**Minutes of the Meeting  
September 3, 1998**

Projects Reviewed

Proposed play area plan (↑ north)

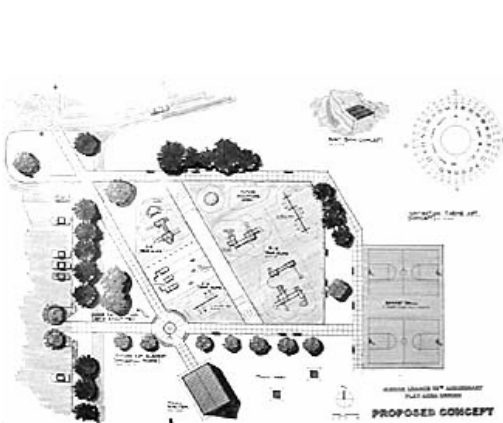
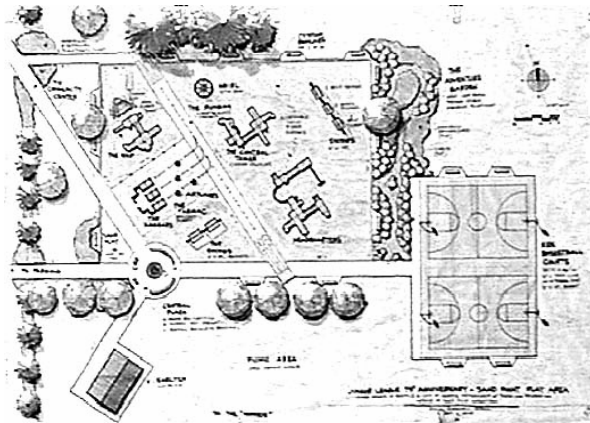
- Dubrow:** I appreciate your taking a serious second look at the project. However, I still have some concerns about the project. The central elements don't seem to be at the centers of activity. Perhaps the circle plaza could be moved to the north end of the diagonal walkway. I don't agree with the two parallel diagonals, but appreciate the reference to the historic runway. Perhaps it could be rotated so that it is parallel with the east and west edges of the play area. The current plan introduces many axis lines that don't lead anywhere. I suggest terminating them with strong visual elements.

- Swift:** I have been thinking about how I would approach the project. The plan seems to be a series of isolated elements with little hierarchy. I think the runway needs to extend over the walkways and through the trees. It needs to have more visual dominance. The circle plaza could have a curved path spun off toward the picnic shelter, rather than the rigid diagonal path. Perhaps the east-west path toward the basketball courts should have a forced perspective to emphasize the vista. The project is currently a group of objects on a level site that don't energize each other.

- Sundberg:** I personally don't mind the diagonals, but they are too equal in scale and dominance. One needs to be made primary and different. You need to play with a hierarchy of the spaces. At this point everything is equal.

- Dubrow:** In this case it is working against you. The diagonal walkway is focused on the overlook toward the forest and Mount Rainier beyond. The geometry of a circular plaza has an inherently inward focus. It is crucial that each element reinforce the form of the next so that all elements have a synergistic connection to the whole.

- Gold:** In order to reinforce the bearing compass at the center.
- Dubrow:** Perhaps the bearing compass is more appropriate at the end of the runway where it intersects with the south walkway.

After reviewing the design in regards to these recommendations the design team concluded that the two diagonals were necessary and that combining them would compromise the function of each. The diagonal runway provides a unifying thematic feature for the play areas on each side while providing a physical buffer between children of different age groups. The runway has been extended over the north and south walkways. The diagonal walkway will maintain an open, visual connection to the Community Center. The picnic shelter has been relocated at a diagonal southwest of the circular plaza. Additional changes include bench re-locations and shifting the basketball courts to the south so that they are centered on the east-west walkway south of the play

The paved walkway on the east and half of the north side has been removed and a new adventure garden has been added at the northeast corner of the play area. A 40 foot grass buffer has been created at the west side, simplifying the play area geometry and allowing space for a small sand play area northwest of the circular plaza.

Exterior photo of central Palm House

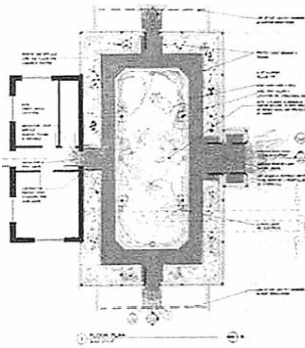
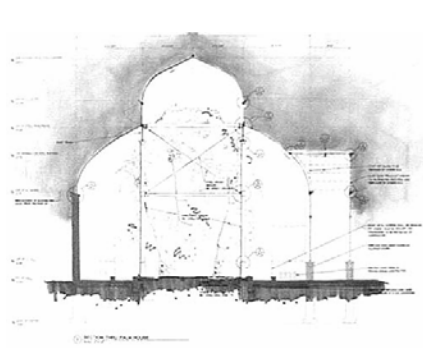
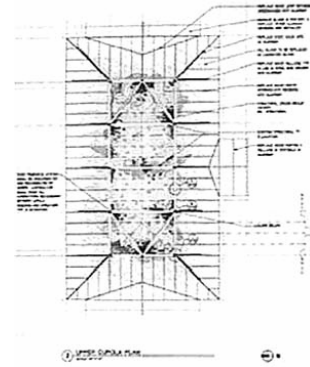
**Dubrow:** In this case, it was the city agency's obligation to pursue nomination of the building as a historic landmark. It clearly passes the common sense test of historic importance. These structural improvements are major alterations, not in-kind replacements, to a significant Seattle landmark. I question the approach to make the new columns replications of period elements without any visual clues that they are not original. Following the Secretary of the Interior's Standards on historic preservation, some effort should be made to identify the new elements as additions and not original to the structure. Were a range of structural schemes considered and evaluated?

**Dubrow:** I still question the compatibility of the columns with the existing structure.
